General Bid Bulletin No. 15
16 July 2021

**THE MALOLOS-CLARK RAILWAY PROJECT AND THE NORTH-SOUTH RAILWAY
PROJECT SOUTH LINE COMMUTER PACKAGE CP NS-01: PROCUREMENT OF
ELECTRICAL AND MECHANICAL SYSTEMS AND TRACK WORKS (IFB No: 21-040-3)**

PACKAGE CP NS-01: E&M SYSTEMS AND TRACK WORKS
General Bid Bulletin No. 15
Annex A

PACKAGE CP NS-01: E&M SYSTEMS AND TRACK WORKS
General Bid Bulletin No. 15
Annex B

SUBSTATION LAYOUT
(SS No. S12)

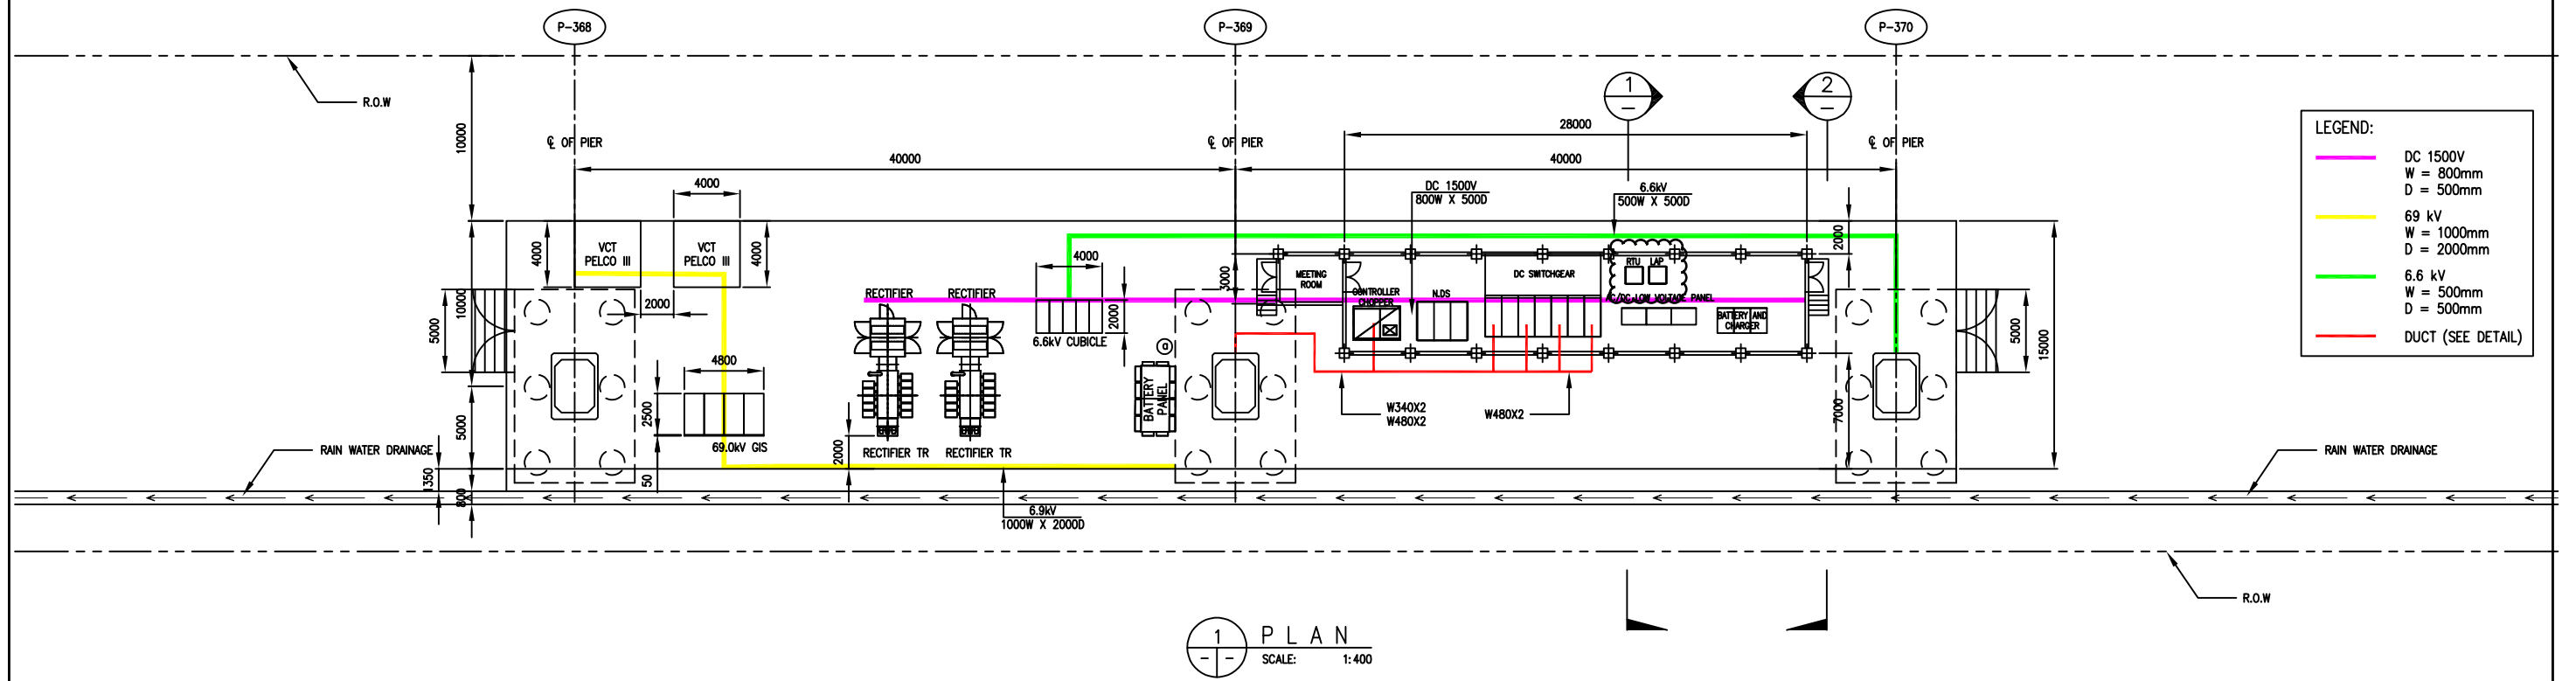
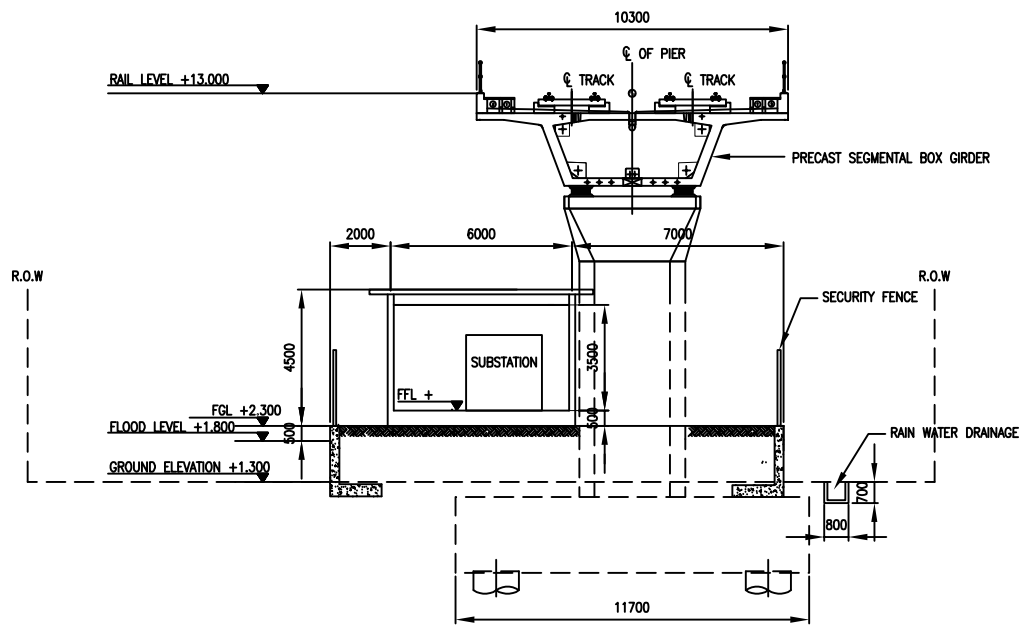
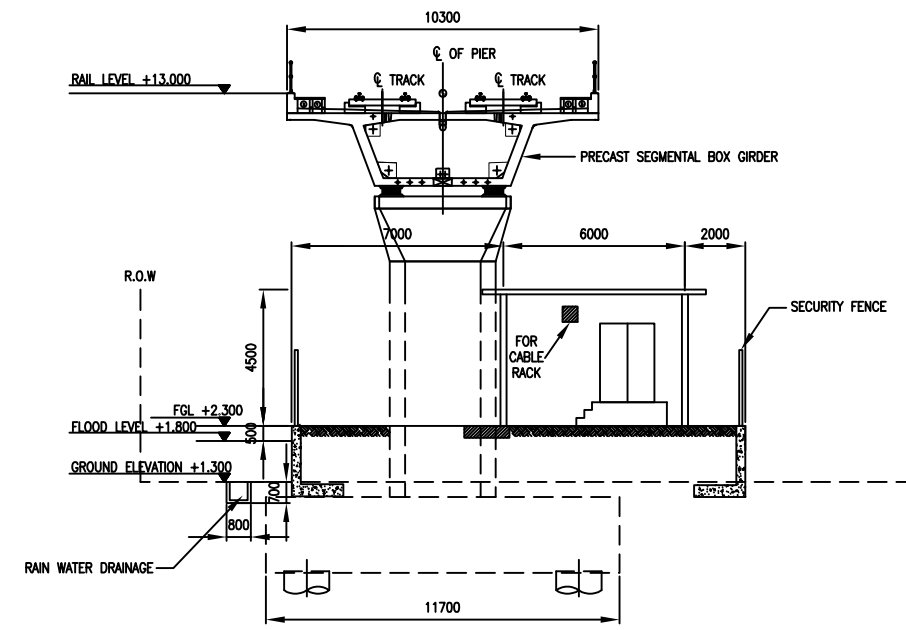
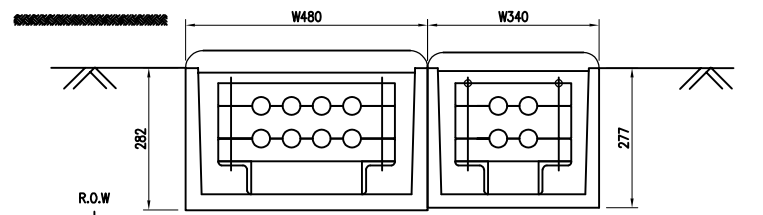
Volume III Part 2 – Employer’s Requirements d) Employer’s Drawings		
7	Part 2 Vol.3 E_M Version 11.0 FINAL Rev. A. ERD (a) page 164	Revised Traction Power Feeding System Drawing
8	GBB-9 Annex B, Item No.16	Substation Layout Drawings (SS No. 10) to (SS No. 22) “Local Annunciator Panel Added”

VERSIONS	DATE	DESCRIPTION
00	02 MAR 2021	ISSUED FOR REFERENCE
01	09 JUN 2021	RESISTOR CHANGED TO BATTERY POST
02	24 JUN 2021	LOCAL ANNUNCIATOR PANEL ADDED

SUBSTATION LAYOUT
(SS No. S13)

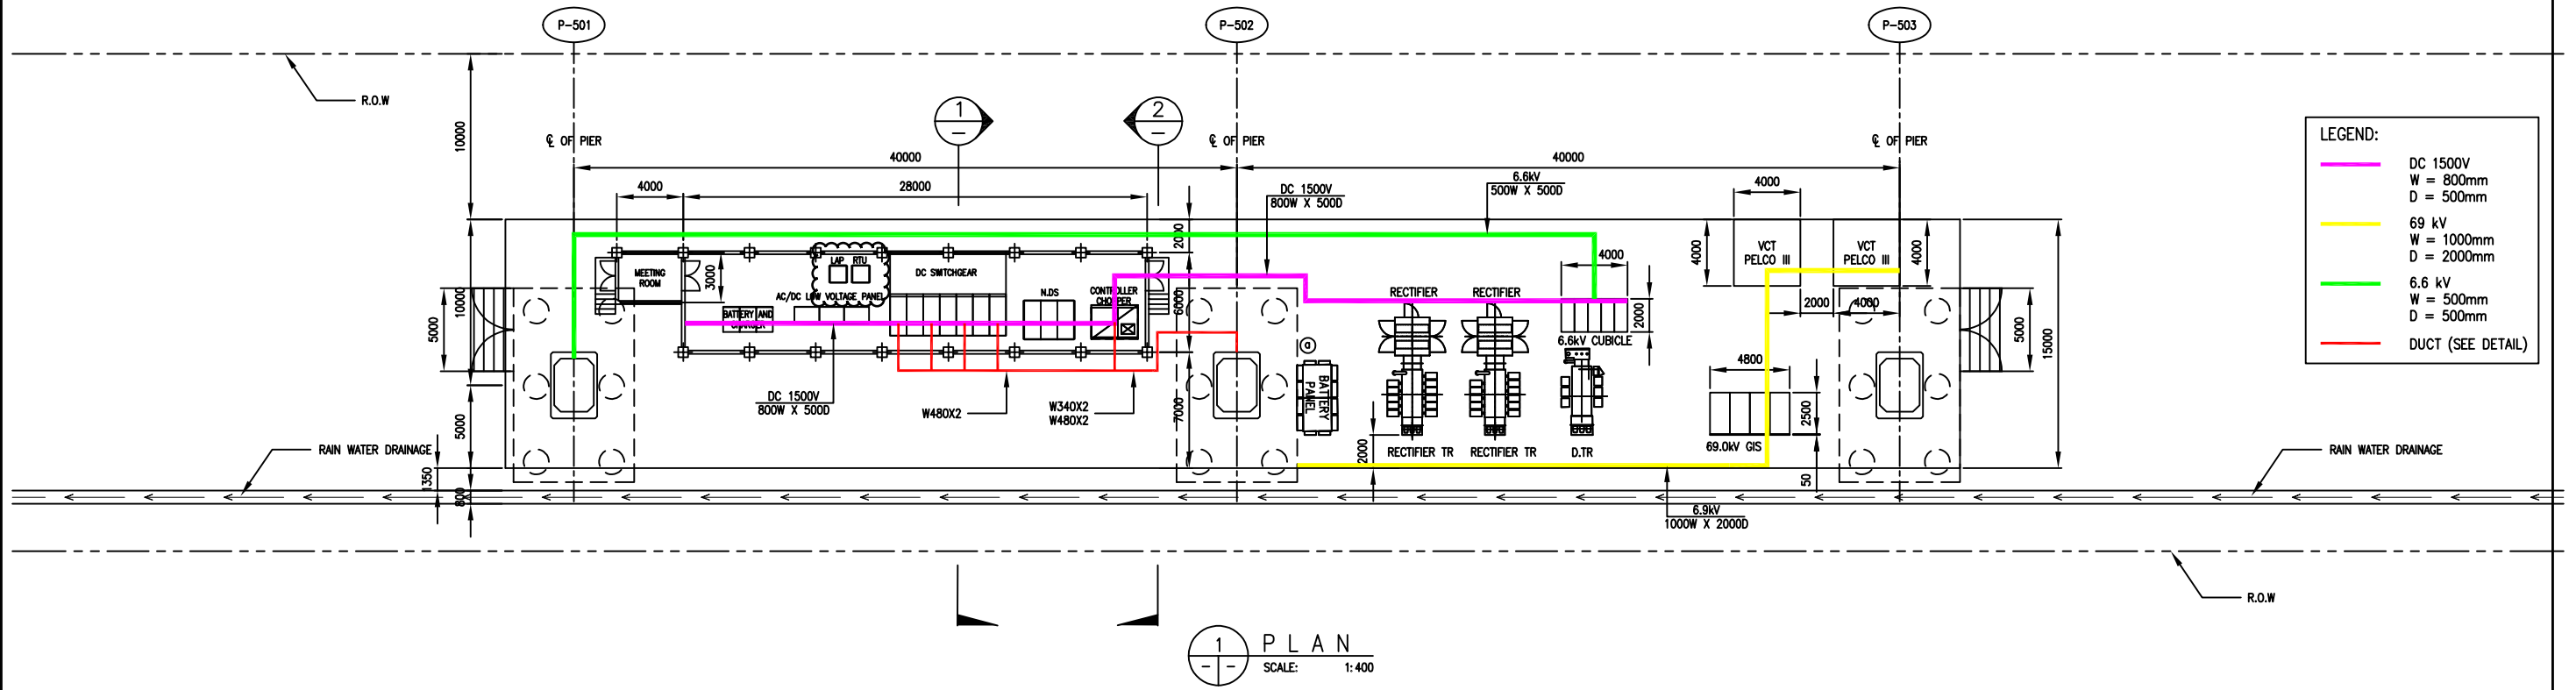
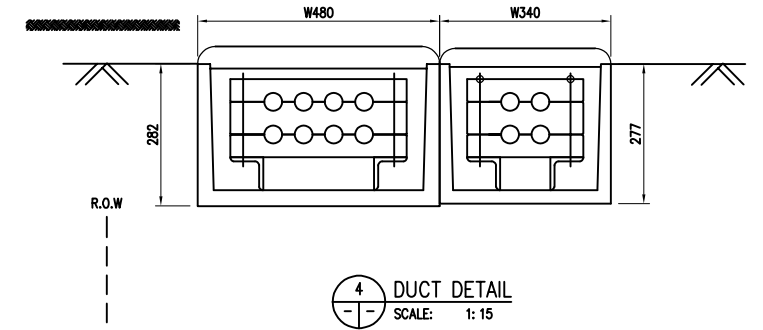
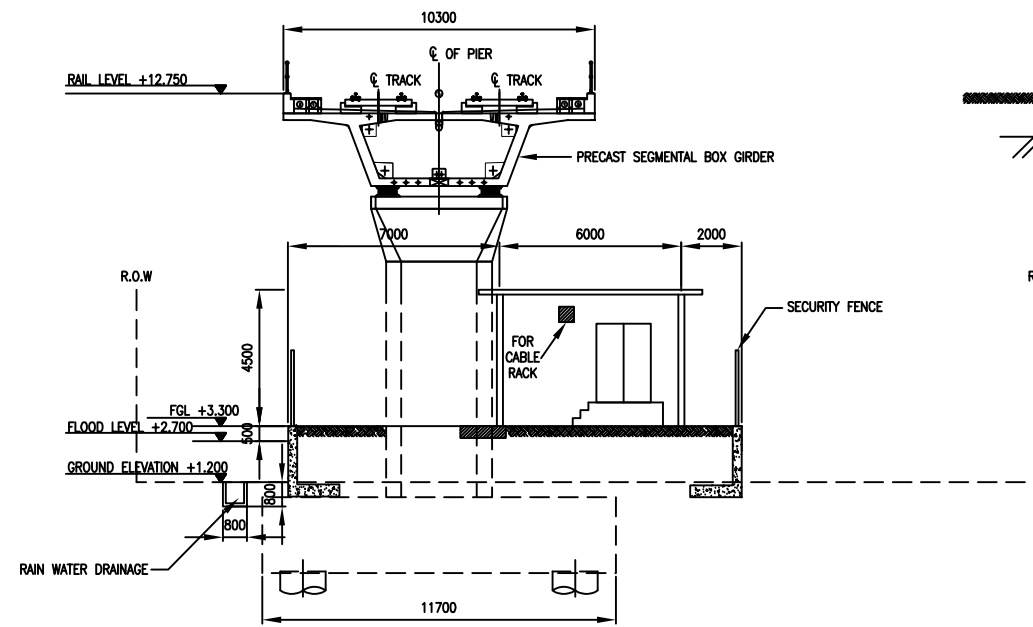
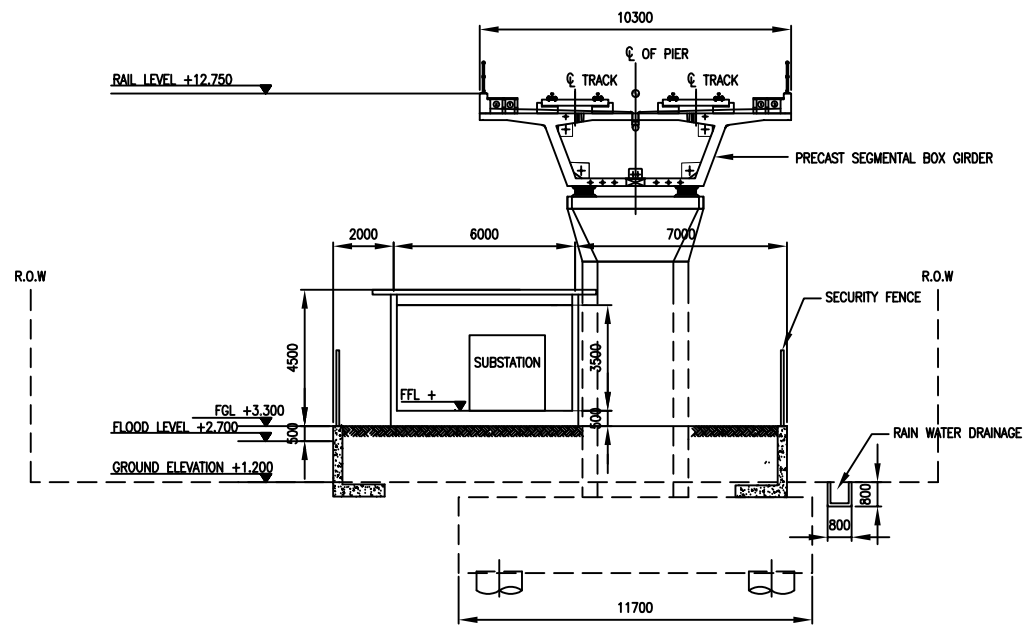
VERSIONS	DATE	DESCRIPTION
00	02 MAR 2021	ISSUED FOR REFERENCE
01	09 JUN 2021	RESISTOR CHANGED TO BATTERY POST
02	24 JUN 2021	LOCAL ANNUNCIATOR PANEL ADDED

SUBSTATION LAYOUT
(SS No. S14)

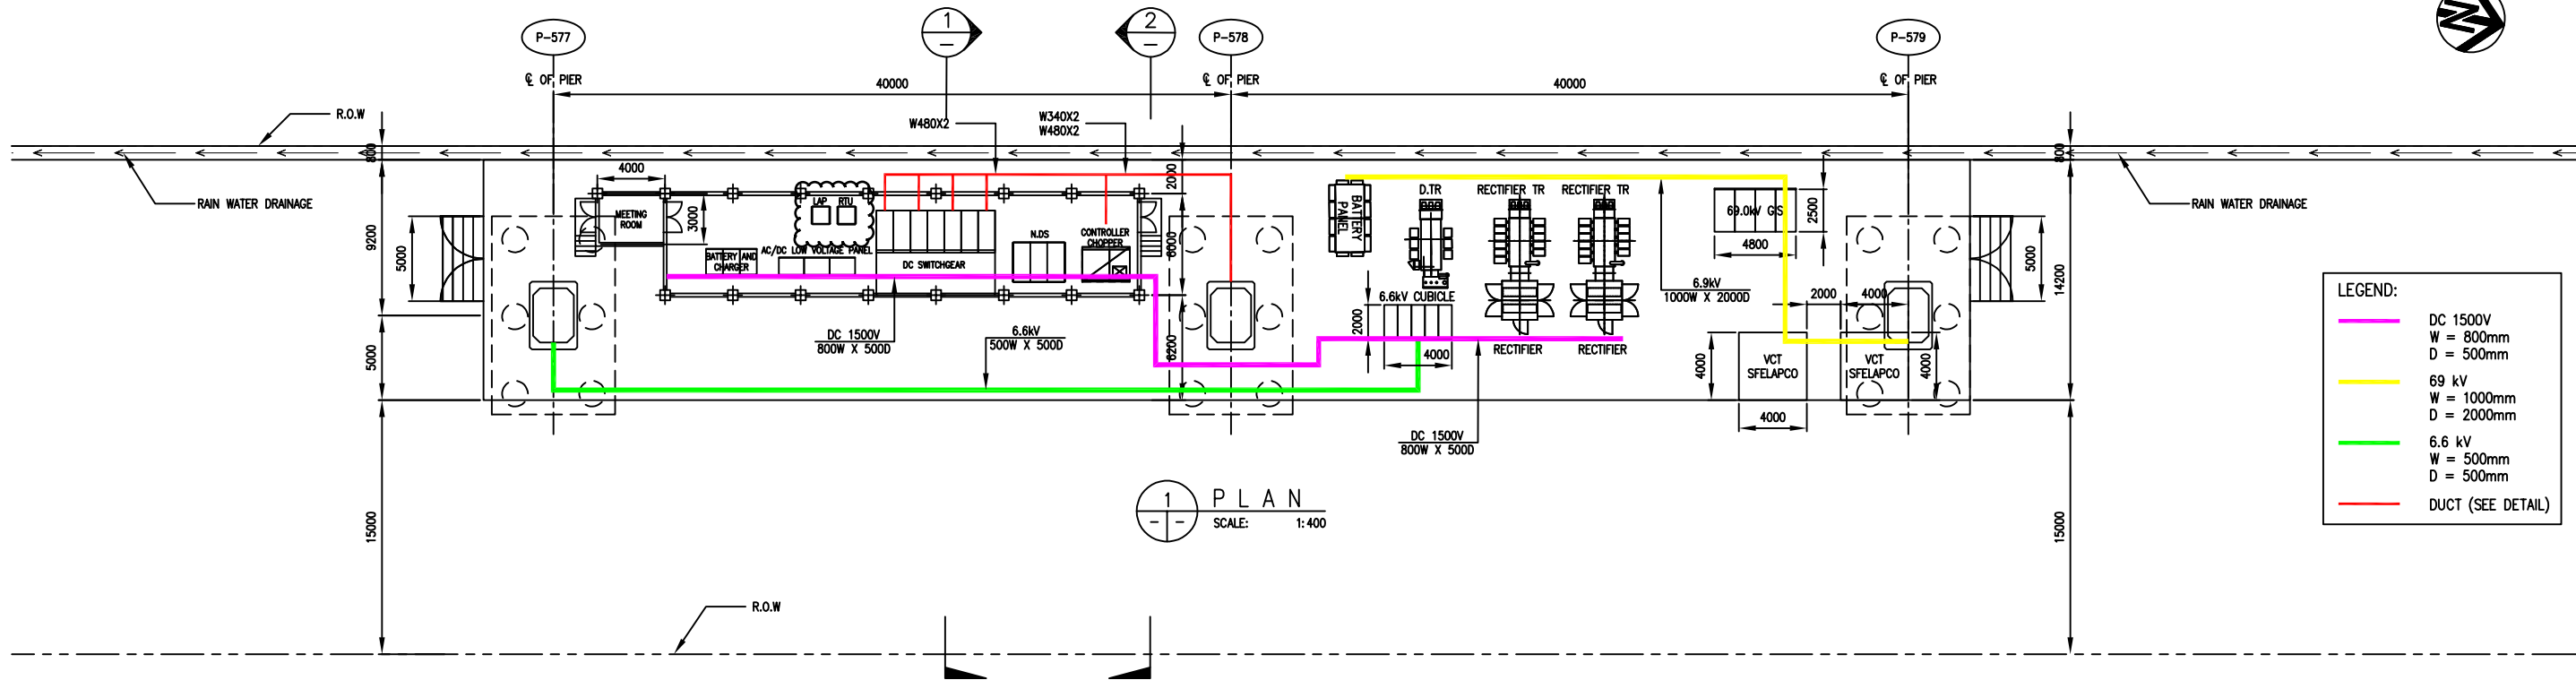
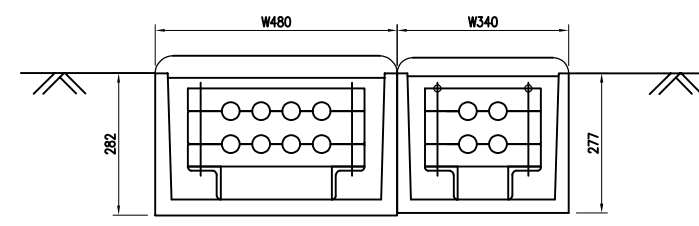
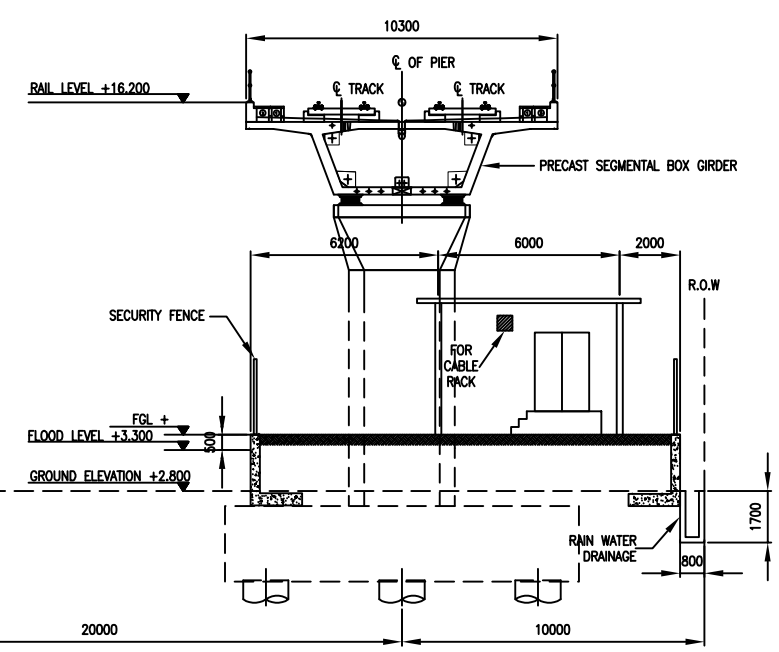
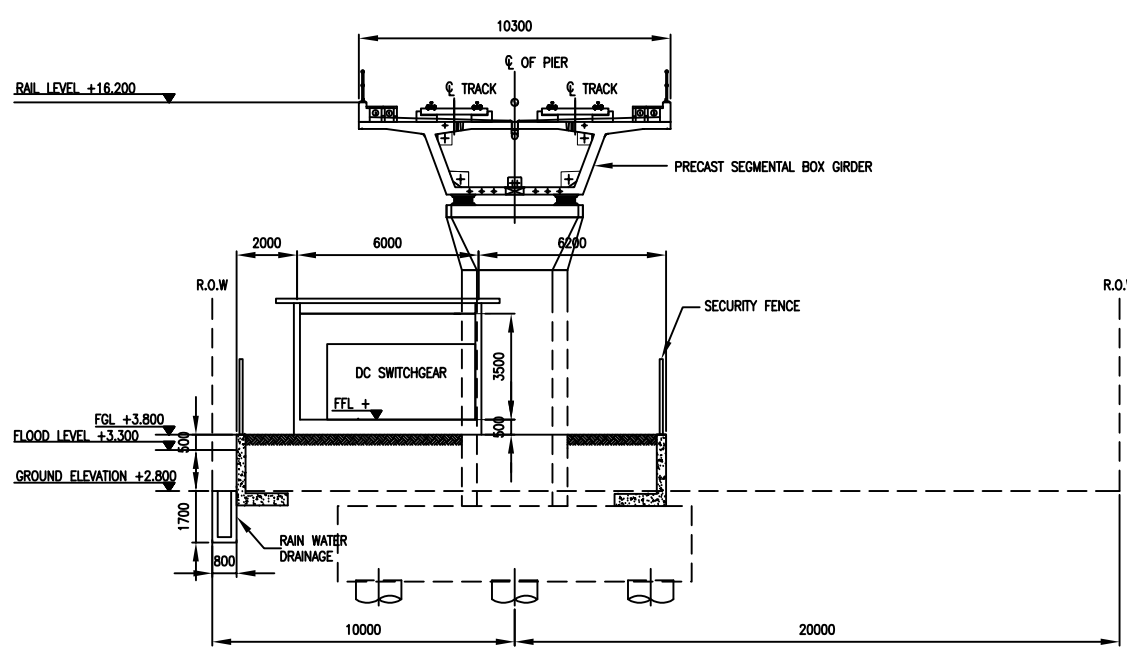
VERSIONS	DATE	DESCRIPTION
00	02 MAR 2021	ISSUED FOR REFERENCE
01	09 JUN 2021	RESISTOR CHANGED TO BATTERY POST
02	21 JUN 2021	LOCAL ANNUNCIATOR PANEL ADDED
